RE: Harbor View Square, Site ID No. C738040
Building No. 1 Vapor Intrusion Investigation & Active SSDS Commissioning Workplan

Re: Harbor View Square, Site ID No. C738040
City of Oswego, Oswego County
Building No. 1 Vapor Intrusion Investigation & Active SSDS
Commissioning Workplan

The New York State Department of Environmental Conservation (Department) and the New York State Department of Health (NYSDOH) have reviewed the Building No. 1 Vapor Intrusion Investigation & Active SSDS Commissioning Workplan (work plan) for Harbor View Square (site), dated August 3, 2021, which was prepared by Synapse Risk Management (Synapse) on behalf of Harbor View Square, LLC (Volunteer). With the modifications set forth below, the work plan is approved.

Figure 1 – Indoor Air / Sub-slab Vapor Sampling Locations.

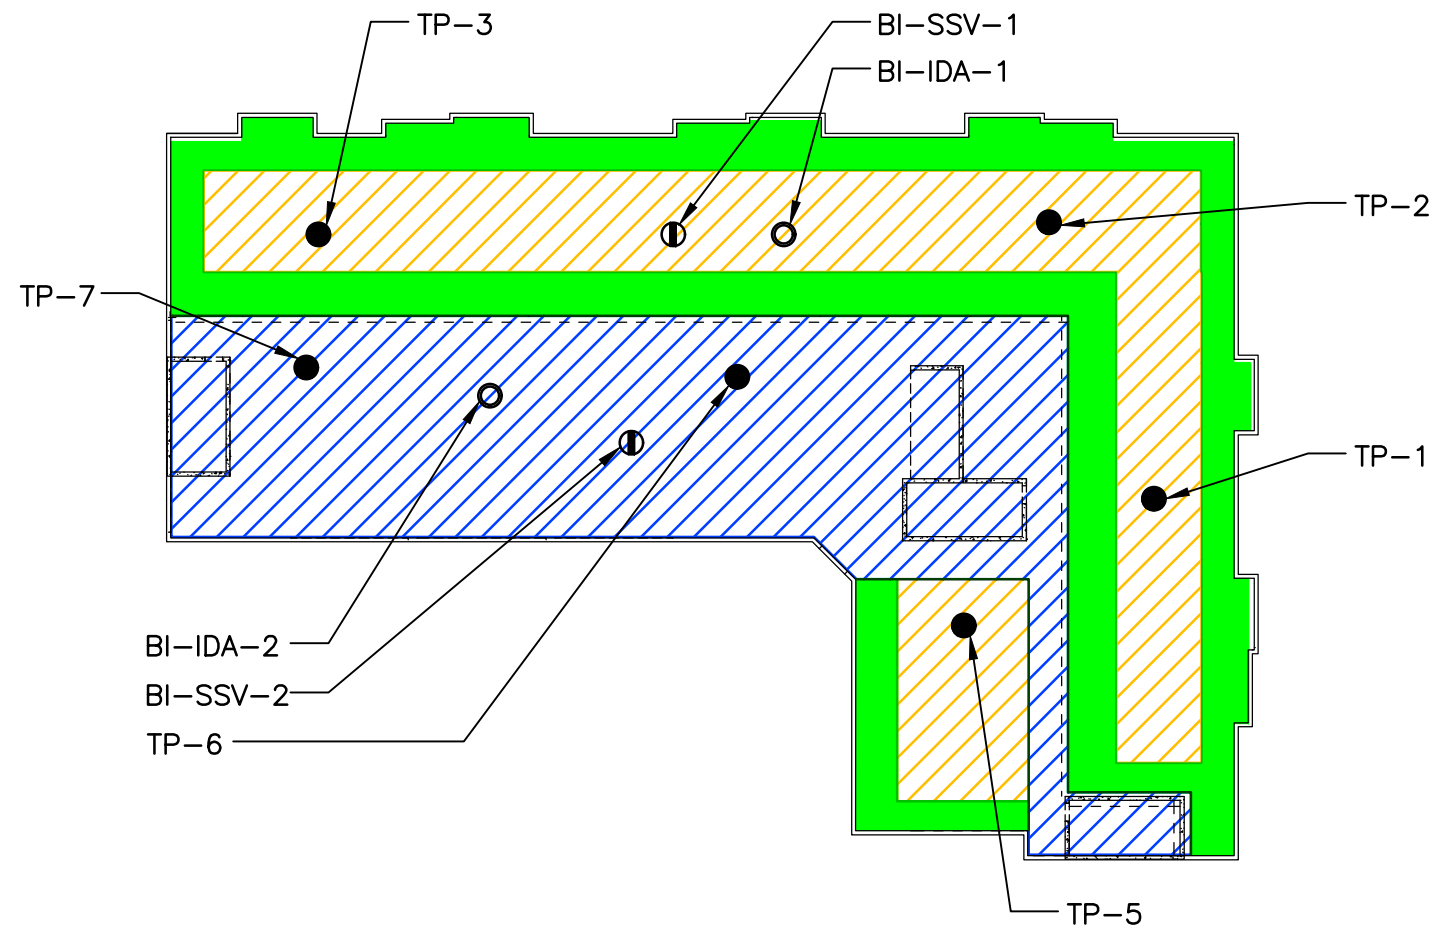
9. Communication test points must be located away from the SSDS piping and near the end of each leg of the SSDS piping furthest from the extraction fan. Based on plan Sheet P-100 – Foundation Plan, dated August 1, 2018 and last updated January 21, 2019, which was submitted with the work plan, the changes listed below are necessary. If any modifications to the SSDS were made after January 21, 2019, then that plan must be submitted, and the locations may require further revision. Ensure all sampling locations are several feet from any building footers.

- a. A test point must be installed west of TP-3, near the northwestern corner of the building.
 - b. A test point must be installed south of the stairwell at the western end of the building.

- c. A test point must be installed east of the stairwell near the southeastern end of the building.
 - d. A test point must be installed south of TP-5, near the southwestern end of the southern extension of the building.

- e. A test point must be installed north of B1-SSV-1, near the north wall of the building, to characterize slab conditions away from the SSDS piping.

- f. A test point must be installed south of B1-SSV-2, near the south wall of the building, to characterize slab conditions away from the SSDS piping. It would be acceptable to simply move TP-6 to this location.

The modifications to the Harbor View Building 1 Vapor Intrusion Investigation & Active SSDS Commissioning Workplan presented in your letter dated August 26, 2021 have been reviewed by the brownfield consultant team and found acceptable.
